Appendix B: Agency Advice Response

Picture 1 Car park check point

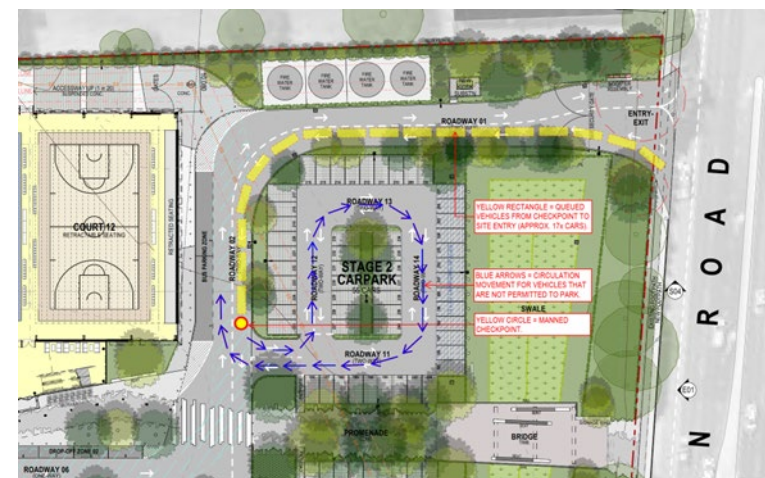
- 4. Traffic Management Plan (TMP)
 - a. The TMP Section 17.2 notes the Lane Closures Controls will include car park closure, no left turn and boom gate. As noted in the TfNSW response dated 18 November 2024, boom gates or manned entry would likely create queuing onto Turton Road and would not be supported.
 - b. Traffic Guidance Scheme TGS4004.DFT V01.2025 – Turton Rd (NISC Car Park) – Lighttower Location: It is recommended that a new development have appropriate lighting to cover all events without the use of temporary lighting. A lighting strategy should be developed.

The TMP does not propose to use boom gates. A check point will be located within the carpark – this is located at 'Checkpoint One' as shown in **Picture 2** below. The location of the control point provides for sufficient vehicle queuing space within the site for seventeen (17) cars. The design of the car park allows for cars without a valid permit to circulate within the Stage 1 carpark and then exit the site. Access to the car park is therefore not anticipated to result in vehicles queuing outside the site or causing delays to the road network.
